November 17, 2015

Re: Environmental Assessment  
Frey Farm Landfill Vertical Expansion  
Permit No. 101389  
Manor Township, Lancaster County

The Department of Environmental Protection (DEP) has completed its initial environmental assessment review of your application and has the following comments:

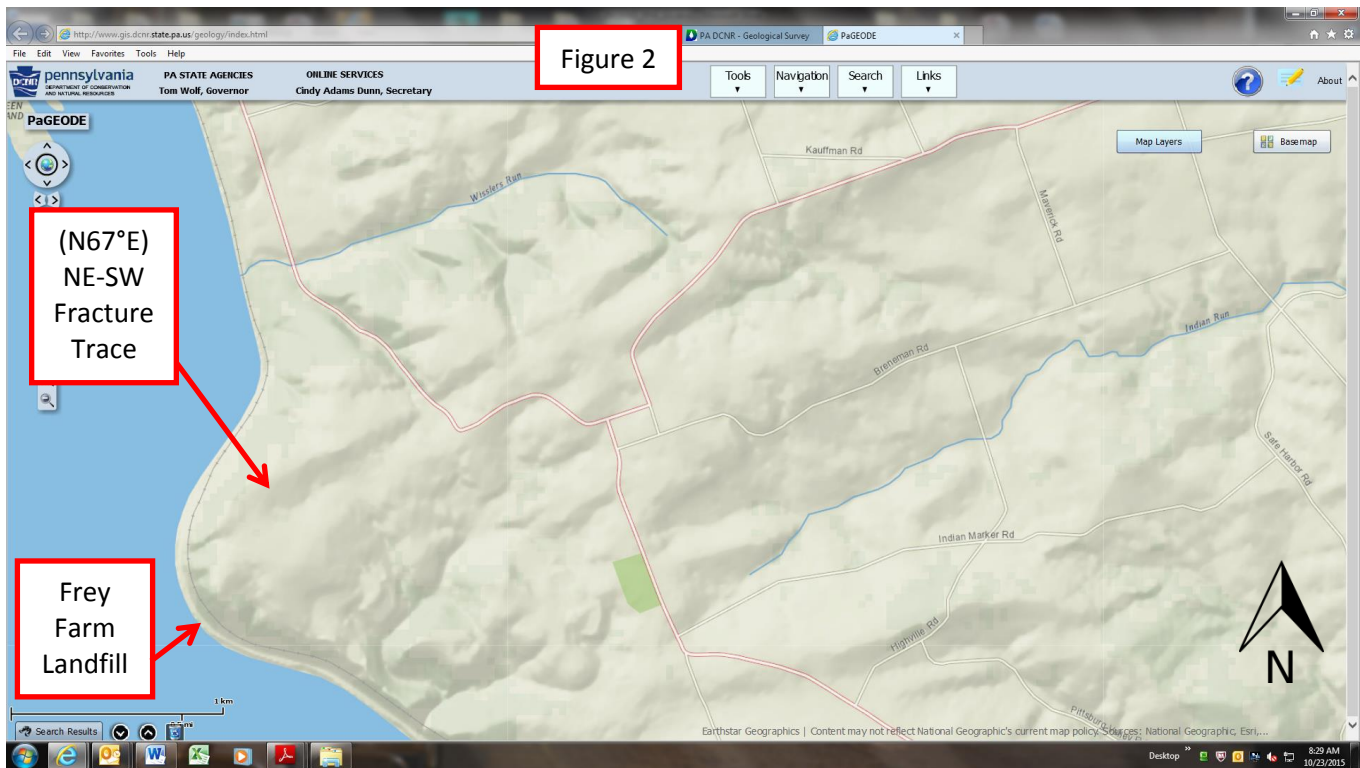
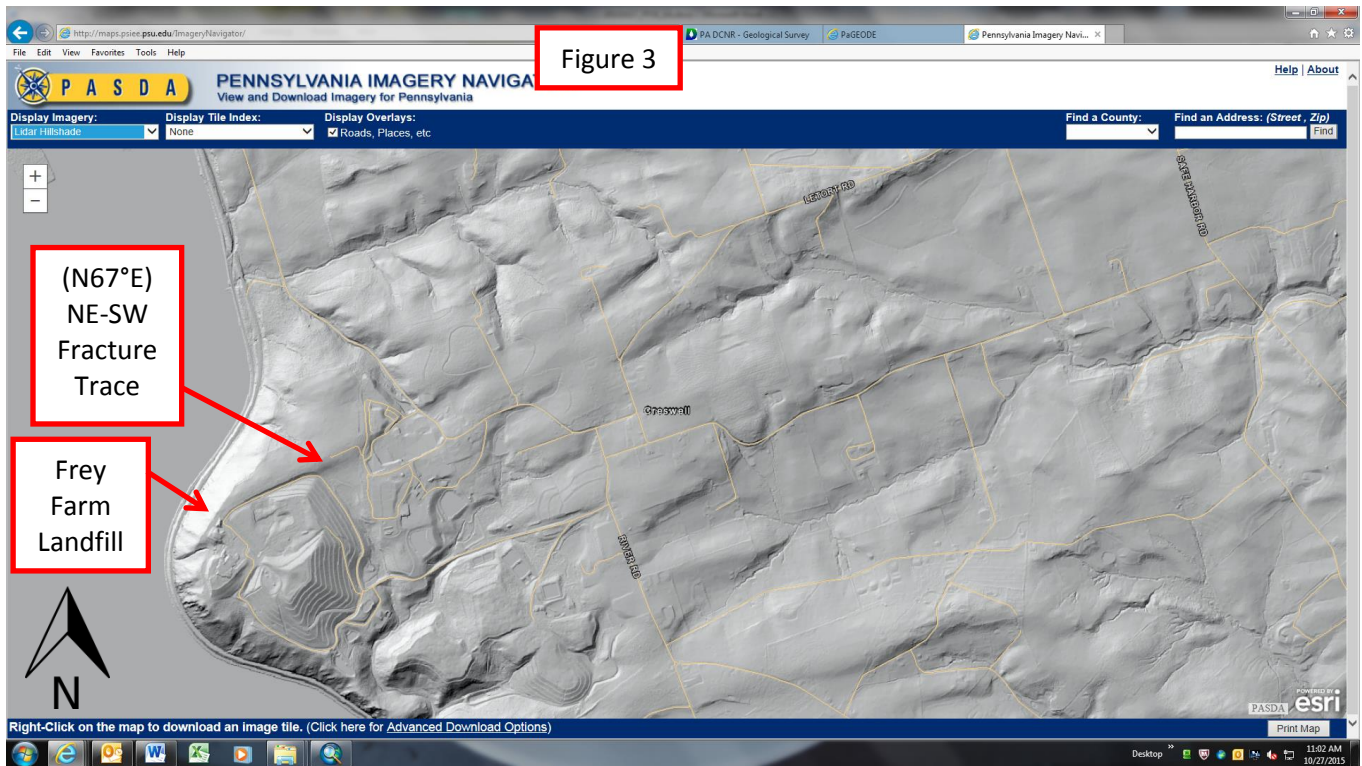
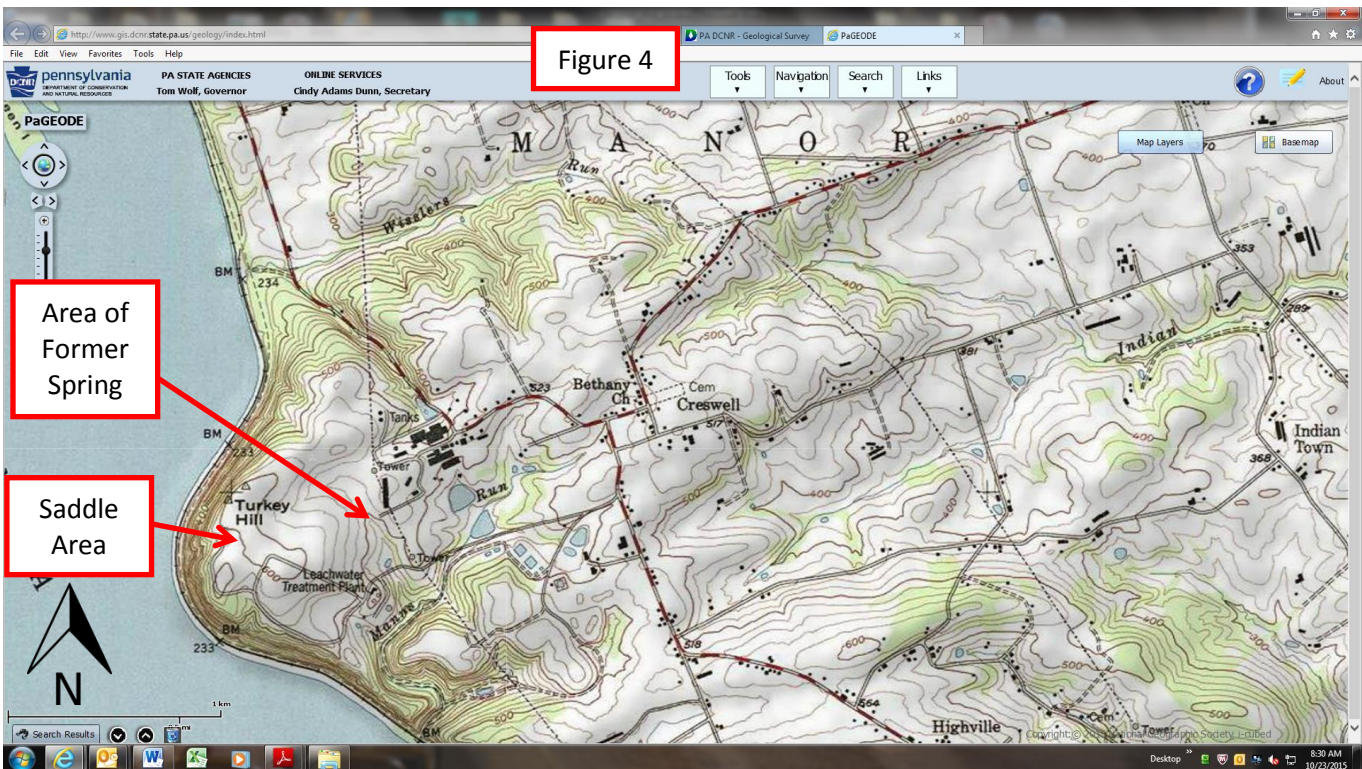
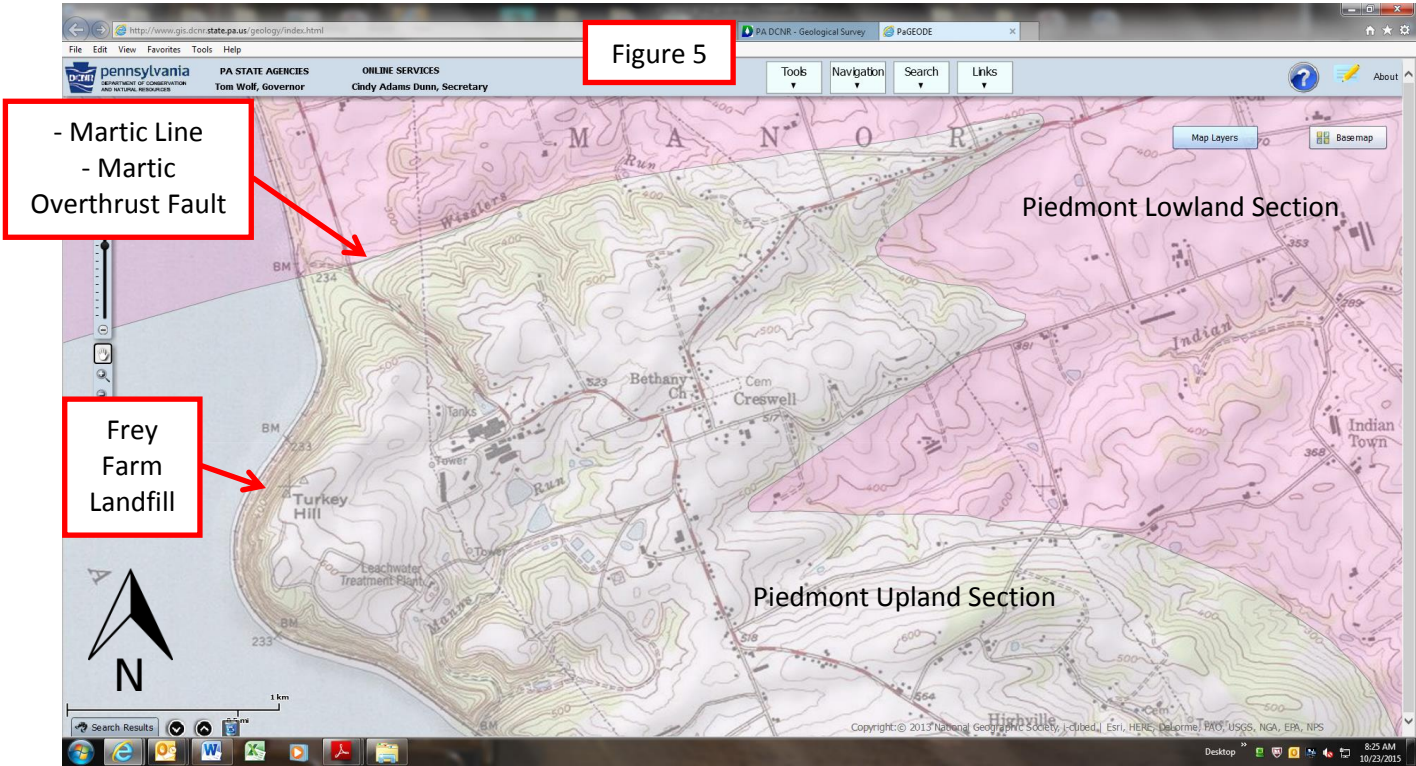
- 3) The DCNR website at <http://www.gis.dcnr.state.pa.us/geology/index.html> and Penn State website at <http://maps.psiee.psu.edu/ImageryNavigator/> provide access to aerials in addition to National Geographic, topographic, light and radar (Lidar), and/or geologic maps of this area. As noted on the attached aerials and maps (i.e. Figure 1, Figure 2, and Figure 3), a fracture or possible fault trends NE-SW in the vicinity of the north side of the existing landfill footprint and is believed to correlate with the N67°E fracture trace documented on the *Phase I, Sheet 8 - Geologic Map* and is located beneath the northern side of the existing disposal area and in close proximity of the north and northwest sides of the proposed FFVE Mechanically Stabilized Earth (MSE) berm. As documented on the attached topographic map (Figure 4), this fracture/fault bisects a topographic high creating a saddle area (i.e. a low point between two areas of higher ground) on the west side of the landfill.

Figure 6

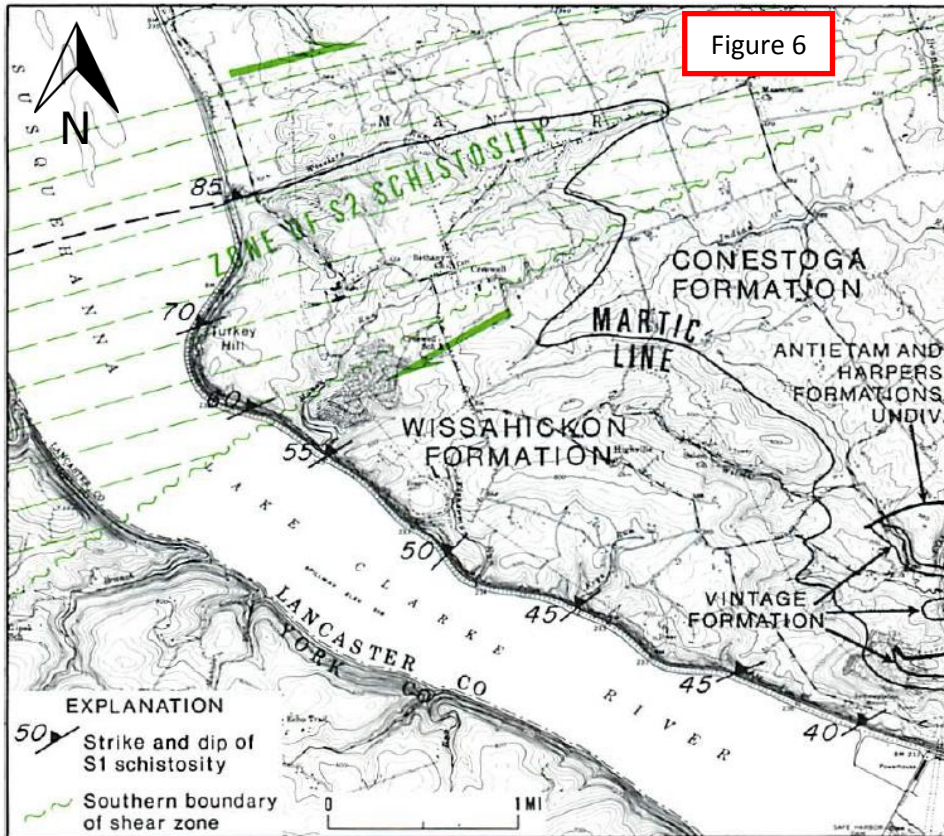
- c) The underlying geology is complexly deformed in the vicinity of Turkey Hill and the proposed FFVE. The attached Figure 6, taken from Pennsylvania Geology (April 1990) publication, illustrates the highly deformed Zone of S2 Schistosity in the vicinity of Turkey Hill, which is more highly deformed than the S1 Schistosity Zone located to the south in-between Turkey Hill and Safe Harbor. The Pennsylvania Geology publication documents that:

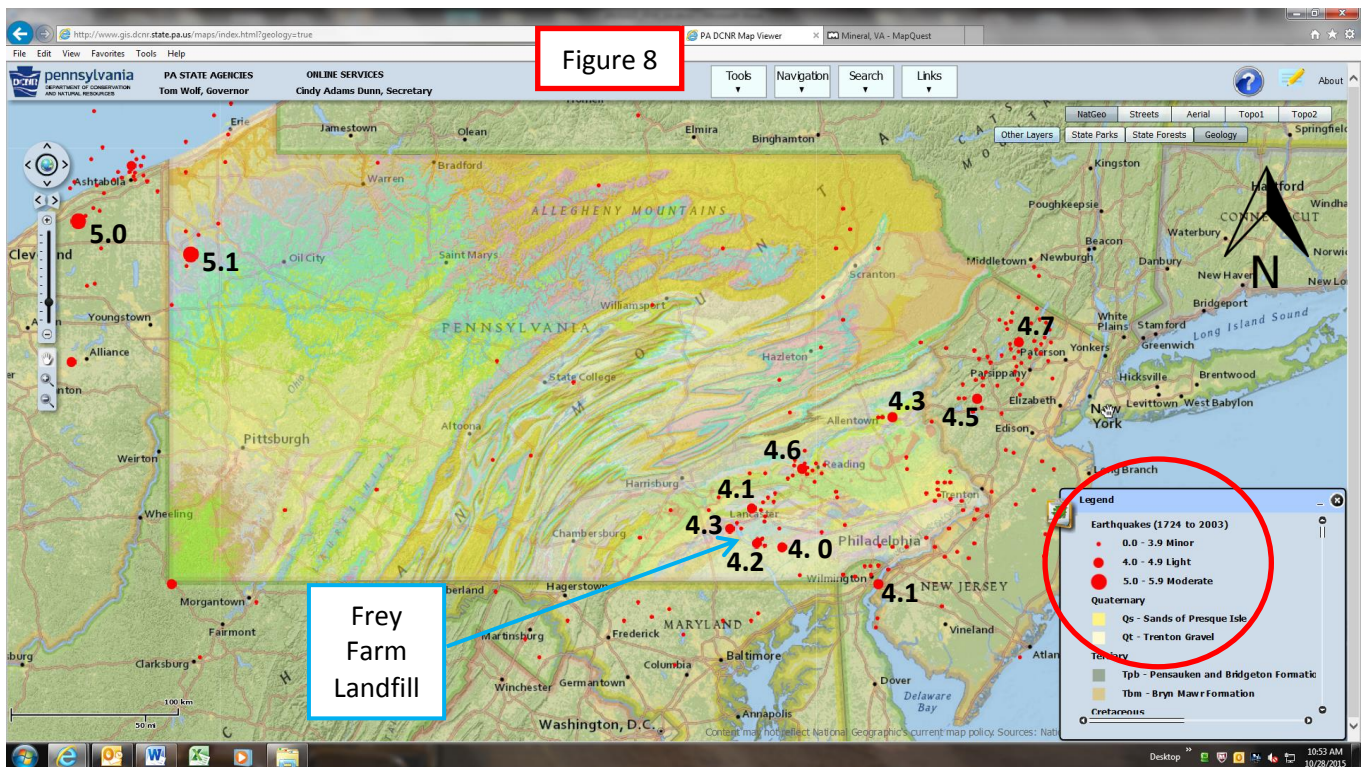
Seismic activity has been documented higher than normal for this area of Pennsylvania due to the nearby Martic Line. As noted on Figure 7, two locations in close proximity of the Frey Farm Landfill documented earthquake activities in 1984 and 1989, at 4.2 and 4.3 magnitudes, respectively. These two points are located just outside the 5-mile radius of the Frey Farm Landfill as noted on Figure 7. The attached Figure 8 illustrates Pennsylvania statewide seismic activity. Both of these maps were created using earthquake data (i.e. circa 1724 to 2003) downloaded from the DCNR website.
